ADDENDUM #4
KEARNEY REGIONAL AIRPORT
NEW HANGAR
KEARNEY, NEBRASKA
1238

Wilkins Hinrichs Stober Architects, L.L.C.
2908 West 39th Street, Suite A
Kearney, Nebraska 68845
308-237-5787

Date Issued: April 3, 2013

2 **ADDENDUM NO. 4 INTERIOR WALL ASSEMBLIES**
 A-1 SCALE: 3/4" = 1'-0"

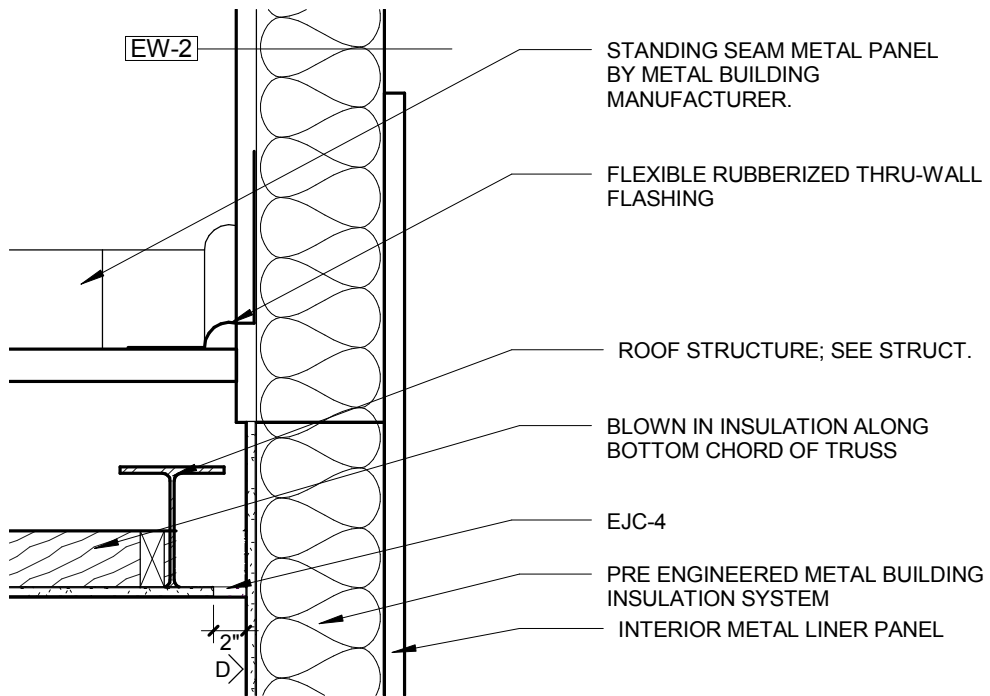
- Addendum #4 - #5 SHEET A2.0 – ENLARGED FLOOR PLANS**
INTERIOR WALL ASSEMBLIES: For interior wall Type “D” use only one layer of GWB, as shown on attachment 2/A1 to Addendum No. 4 dated April 3, 2013.

1 **ADDENDUM NO. 4 - 6/A7.0 - Callout of Section 2**
 A-1 SCALE: 1" = 1'-0"

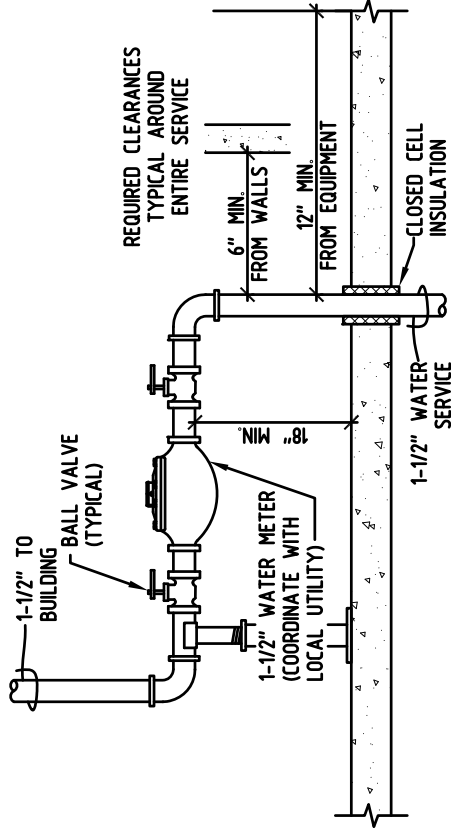
- Addendum #4 - #7 SHEET A7.0 – WALL SECTIONS**
6/A7.0 – WALL SECTION: Make changes to flashing, expansion joint and wall as shown on attachment 1/A1 to Addendum No. 4 dated April 3, 2013
